Well Name: SHANGHAI ROOSTER 15-10 FEDERAL	Well Location: T25S / R29E / SEC 15 / SESE / 32.123702 / -103.966674	County or Parish/State: EDDY / NM
Well Number: 806H	Type of Well: CONVENTIONAL GAS WELL	Allottee or Tribe Name:
Lease Number: NMNM14778	Unit or CA Name:	Unit or CA Number:
US Well Number: 3001550095	Well Status: Approved Application for Permit to Drill	Operator: XTO ENERGY INCORPORATED

Type of Submission: Notice of Intent

Type of Action: APD Change

Procedure Description: **Well Name and Number Changes, Surface Hole Location Change, Bottom Hole Location Change, First and Last Take Point Changes, and Casing/Cement XTO Energy, Inc. requests permission to make the following changes to the original APD: Change Well Name and Number from Shanghai Rooster 22-27 Fed 128H to Shanghai Rooster 15-10 Fed 806H Change SHL fr/375'FSL & 910'FEL to 370' FSL & 885' FEL, Section 15-T25S-R29E No Additional Surface Disturbance Change BHL fr/200'FSL & 333'FEL, Section 27-T25S-R29E to 200'FNL & 330'FEL, Section 10-T25S-R29E Change FTP fr/330'FNL & 333'FEL to 330'FSL & 330'FEL Change LTP fr/330'FSL & 333'FEL to 330'FNL & 330'FEL Attachments: C102 Drilling Program Directional Plan MBS

Wellhead diagram during skidding operations

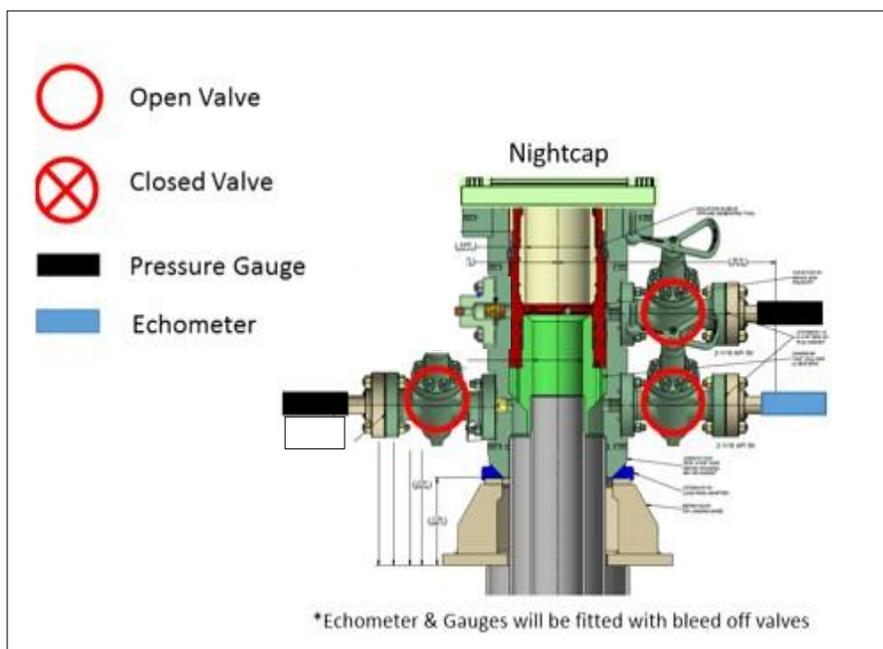
6. Skid rig to next well on pad.
7. Confirm well is static before removing cap flange, flange will not be removed and offline cementing operations will not commence until well is under control. If well is not static, casing outlet valves will provide access to both the casing ID and annulus. Rig or third party pump truck will kill well prior to cementing or nipping up for further remediation.

- a. Well Control Plan
 - i. The Drillers Method will be the primary well control method to regain control of the wellbore prior to cementing, if wellbore conditions do not permit the drillers method other methods of well control may be used

- ii. Rig pumps or a 3rd party pump will be tied into the upper casing valve to pump down the casing ID
 - iii. A high pressure return line will be rigged up to lower casing valve and run to choke manifold to control annular pressure

- iv. Once influx is circulated out of the hole, kill weight mud will be circulated
 - v. Well will be confirmed static
 - vi. Once confirmed static, cap flange will be removed to allow for offline cementing operations to commence

8. Install offline cement tool
9. Rig up cement equipment

Wellhead diagram during offline cementing operations

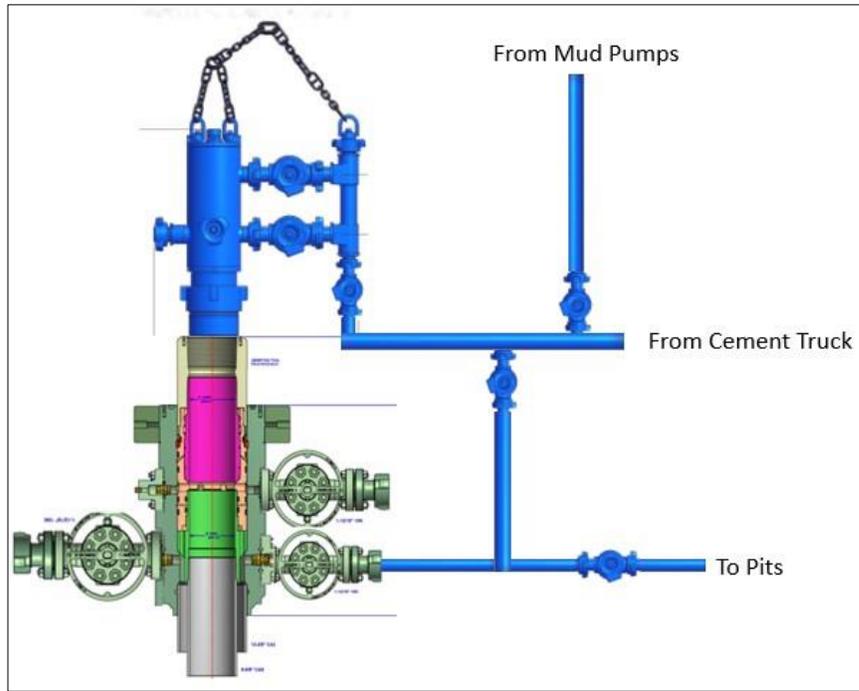
10. Circulate bottoms up with cement truck
 - a. If gas is present on bottoms up, well will be shut in and returns rerouted through gas buster to handle entrained gas
 - b. Max anticipated time before circulating with cement truck is 6 hrs
11. Perform cement job taking returns from the annulus wellhead valve
12. Confirm well is static and floats are holding after cement job
13. Remove cement equipment, offline cement tools and install night cap with pressure gauge for monitoring.

Note: Picture below highlights BOP components that will be tested during batch operations

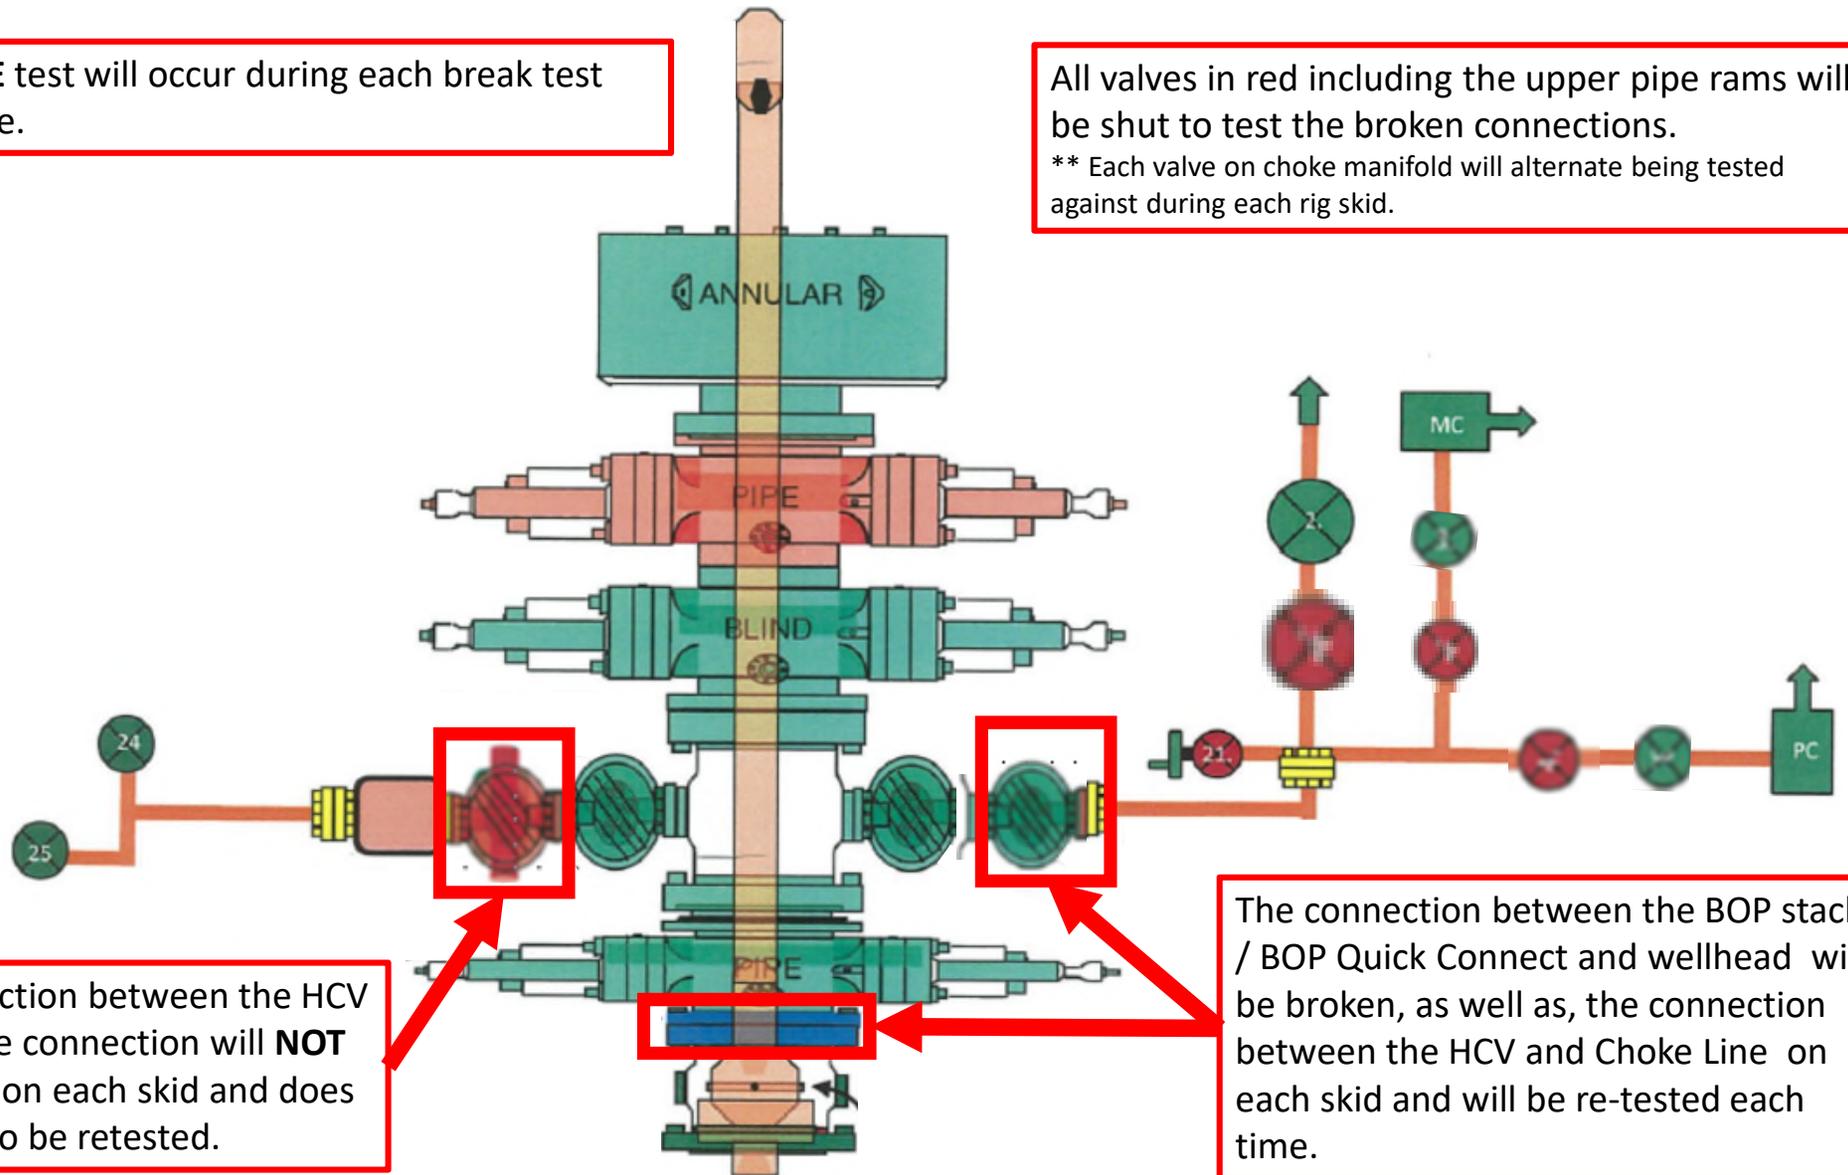
All valves in red including the upper pipe rams will be shut to test the broken connections.
** Each valve on choke manifold will alternate being tested against during each rig skid.

The connection between the HCV and kill line connection will **NOT** be broken on each skid and does not need to be retested.

The connection between the BOP stack / BOP Quick Connect and wellhead will be broken, as well as, the connection between the HCV and Choke Line on each skid and will be re-tested each time.

- BOPE Break Testing is ONLY permitted for 5M BOPE or less.
- BOPE Break Testing is NOT permitted to drilling the production hole section.
- While in transfer between wells, the BOPE shall be secured by the hydraulic carrier or cradle.
- Any well control event while drilling require notification to the BLM Petroleum Engineer prior to the commencement of any BOPE Break Testing operations.
- A full BOPE test is required prior to drilling the first deep intermediate hole section. If any subsequent hole interval is deeper than the first, a full BOPE test will be required.
- The BLM is to be contacted (575-689-5981 Lea County) 4 hours prior to BOPE tests.
- As a minimum, a full BOPE test shall be performed at 21-day intervals.
- In the event any repairs or replacement of the BOPE is required, the BOPE shall test as per Onshore Oil and Gas Order No. 2.
